Access Compliance Report

Public Rights-of-Way

Intersection ID: 2891	Main Street: BEAROAK_LN	Cross Street: RIDGEFIELD_DR	Location: W
ADA ID: FBBF803A89AA	Ramp Type: PerpDiag	Initial Pass/Fail: Fail	Overall Compliance: No
			Severity Score: 33.75

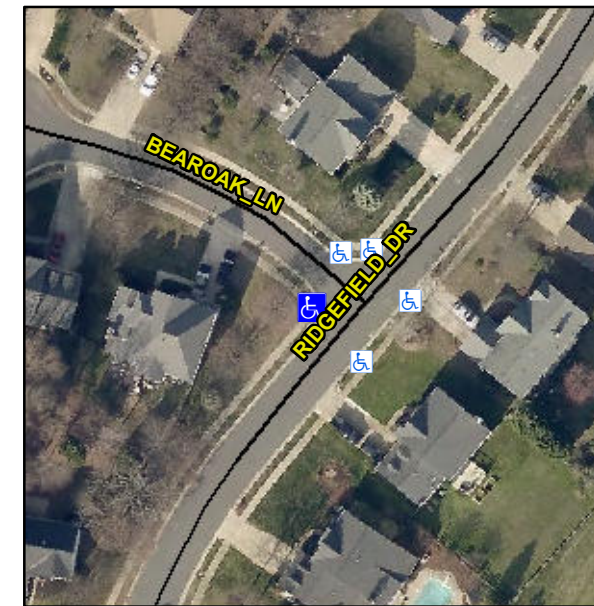
Not Found, R304.5.1, R304.2.2, R304.5.3

Compliance	Description	Data	Compliance	Description	Data
N/A	Ramp Length (in)	52.0	No	Ramp Slope (%)	8.7
No	Ramp Width (in)	41.0	No	Ramp XSlope (%)	6.1
N/A	Flare Type LT	N/A	N/A	Flare Type RT	N/A
N/A	Flare Slope LT (%)	N/A	N/A	Flare Slope RT (%)	N/A
N/A	Flare Traversable LT?	N/A	N/A	Flare Traversable RT?	N/A
N/A	Landing Length (in)	N/A	N/A	DWS Provided?	N/A
N/A	Landing Width (in)	N/A	N/A	DWS Contrast?	N/A
N/A	Landing Slope (%)	N/A	N/A	DWS Length (in)	N/A
N/A	Landing X Slope (%)	N/A	N/A	DWS Full Width?	N/A
N/A	Landing Curb? (Y/N)	N/A	N/A	DWS Offset (in)	N/A
N/A	Shared Landing?	N/A			
N/A	Gutter Ponding?	N/A	N/A	Gutter Slope (%)	N/A
N/A	Gutter Lip Ht (in)	N/A	N/A	Gutter X Slope (%)	N/A
N/A	Painted X Walk1?	No	N/A	Painted X Walk2?	No
	X Walk 1 Direction	To SE		X Walk 2 Direction	To NE
N/A	X Walk 1 Width (in)	N/A	N/A	X Walk 2 Width (in)	N/A
	X Walk 1 Slope (%)	5.9		X Walk 2 Slope (%)	1.9
	X Walk 1 X Slope (%)	1.4		X Walk 2 X Slope (%)	5.4

Remove & Replace Curb Ramp With Two New Directional Ramps or Equivalent.
